TECHNICAL INFORMATION

67367

- Subject** ▶ Change of Pan Head Screws
- For Models** ▶ DA4030, DA4031
- Country** ▶ All countries
- Description** ▶ Pan Head Screws have been replaced by Hex. Socket Head Bolts with adhesive.

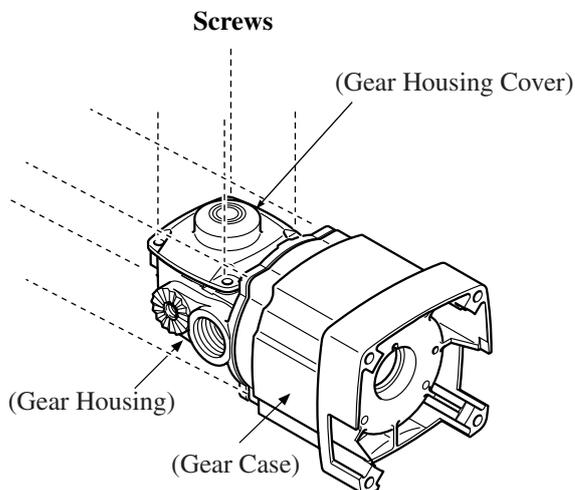
▶ Current	▶ New
Pan Head Screw M5x16  (911223-4)	Hex. Socket Head Bolt M5x16  (266086-6)

Note:
Fasten Hex. Socket Head Bolt M5x16 at 2.9 - 4.9 N.m (30 - 50 kgf.cm) torque.
